DHDC 24-00355

CERTIFICATE OF APPROPRIATENESS

**RE: Application Number 24-00355; 1108 VAN DYKE; WEST VILLAGE Historic District
Project Scope: DEMOLISH GARAGE; ERECT GARAGE; REHABILITATE DWELLING**

SITE PLAN
 SCALE: 1/8"=1'-0"

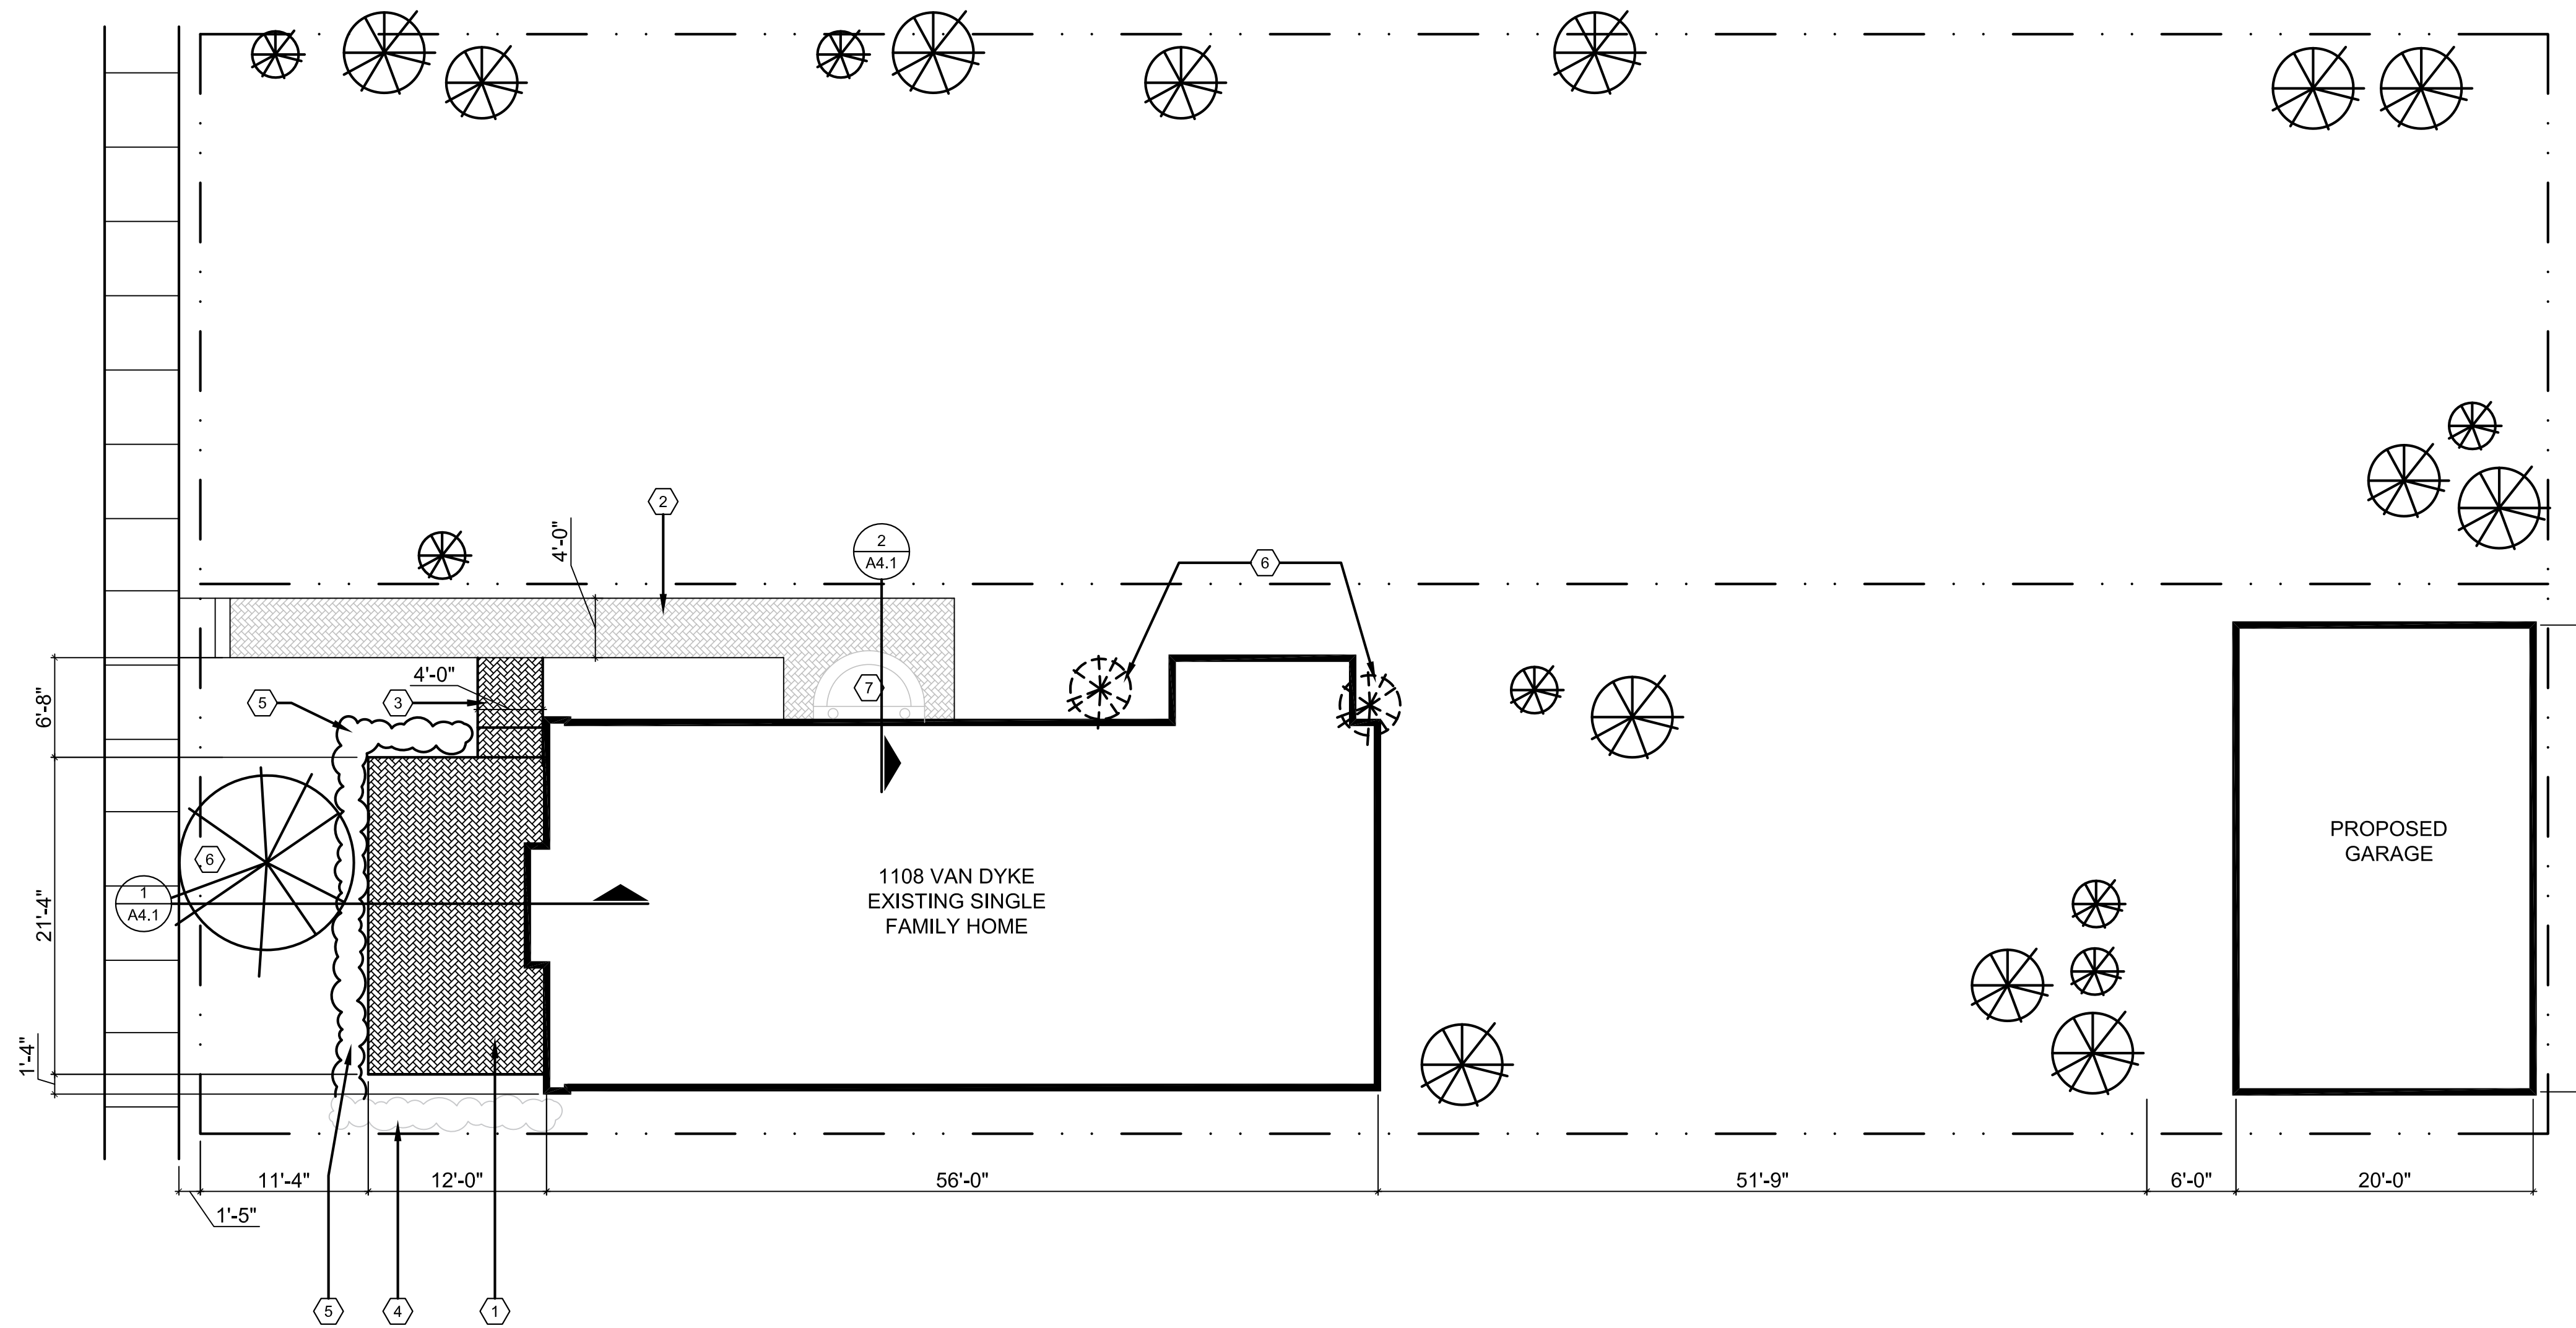
- The new patio design shall be executed per the drawings submitted to the HDC on 7/10/2024 (see the attached)
- The existing honey locust tree to the west of the house shall be evaluated to see if it can be safely trimmed/cut back to preserve and protect the structure. An arborist will submit a report to confirm if this is possible to staff for review
- If the honey locust tree to the west of the house will be kept, the construction drawings shall be revised to show protection around its dripline to ensure its health during construction of the patio
- If the honey locust tree to the west of the house will be removed, it shall be replaced with a new large shade tree
